**Re: National Phase in China of PCT/US2005/001402**  
In the name of Battelle Memorial Institute  
Title: Methods and Apparatus for Producing Ferrate (VI)  
CN Application No.: 200580002471.5  
Your Ref.: 22114(1)CN  
Our Ref.: 080600408

## Text of the First Office Action

Application No.: 2005800024715

The present application relates to electrochemical cells and methods of operating the same, as well as methods for making ferrate. Upon examination, [the Examiner] now provides the following examination opinions.

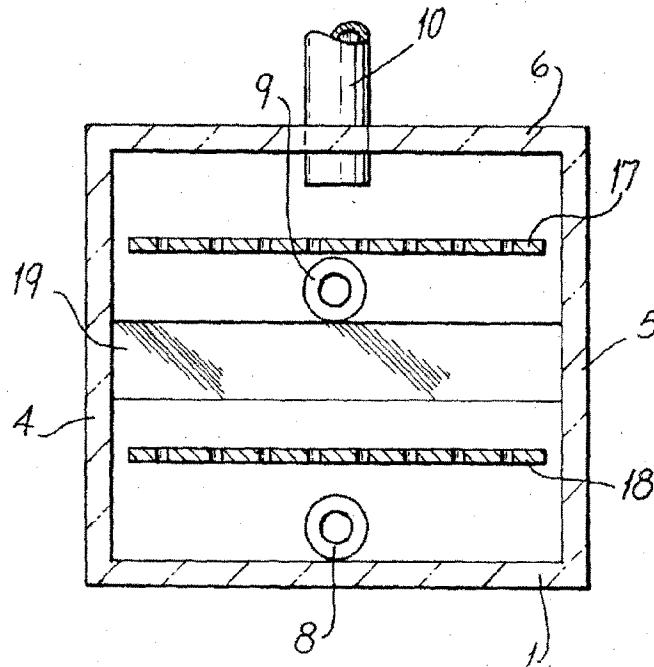
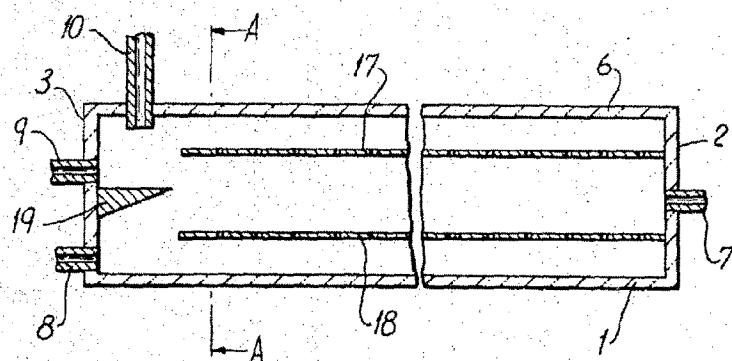
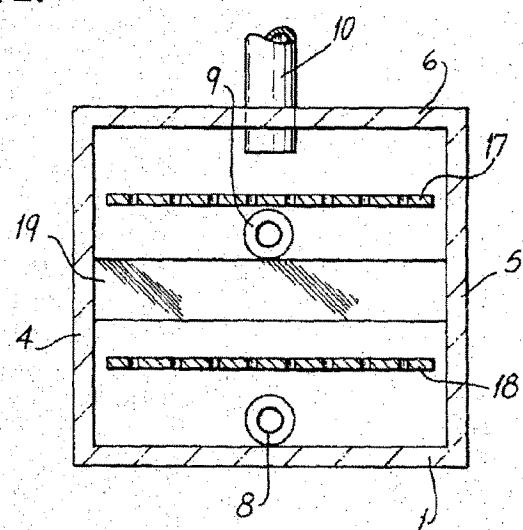
1. Claim 1 seeks protection for an undivided electrochemical cell. Reference 1 (US4256551) disclosed an undivided electrochemical cell without membrane therein, comprising a housing defining an undivided chamber, the housing having an electrolyte inlet port 7, an outlet port 8 for liquid chlorine along with brine, an outlet port 9 for sodium hydroxide solution along with brine and an outlet port 10 for hydrogen, the chamber being provided with a cathode 17 and an anode 18 and filled with an electrolyte, wherein said cathode may be nickel or mild steel mesh and said anode may be titanium mesh (both the anode and the cathode are not gas diffusion electrodes) (see the abstract; columns 1-2 and the contents from line 39 in column 4 to line 42 in column 5 of the description; and FIGS. 1, 2 and 3 of Reference 1). Thus it can be seen that Reference 1 has disclosed all the technical features of claim 1 and their technical schemes are the same; additionally, the technical scheme disclosed by Reference 1 and that sought for protection in claim 1 belong to the same technical field, can solve the same technical problem, and can produce the same technical effect. Therefore, the technical scheme sought for protection in claim 1 does not possess novelty.

2. Claim 2 depends on claim 1, and its additional technical feature further defines the electrolyte outlets; however, said additional technical feature also has been disclosed by Reference 1 (see lines 22-42 in column 5 of the description and FIGS. 1, 2 and 3 of Reference 1): the cell housing was provided with an outlet port 8 for liquid chlorine along with brine and an outlet port 9 for sodium hydroxide solution along with brine, i.e., it had two electrolyte outlets. Therefore, when the cited claim does not possess novelty, claim 2 does not possess novelty either.

3. Claim 3 depends on claim 1 and claim 4 depends on claim 3, but their additional technical features also have been disclosed by Reference 1 (see lines 1-42 in column 5 of the description and FIGS. 1, 2 and 3 of Reference 1): the cell was provided with a splitter 19 (serving as a fluid flow controller of a weir structure) in fluid communication with the electrolyte outlets, controlling the flow of the electrolyte through the outlets to control the flow of the brine electrolyte over the surfaces of the cathode and the anode. Therefore, when the cited claim does not possess novelty, claims 3 and 4 do not possess novelty either. Meanwhile, selecting the fluid flow controller from flow restrictions, valves, screens, fluid flow constrictions or bends only relates to common option in the relevant field of technology; that is to say, when the above fluid flow controllers are selected, claim 4 does not possess inventiveness.
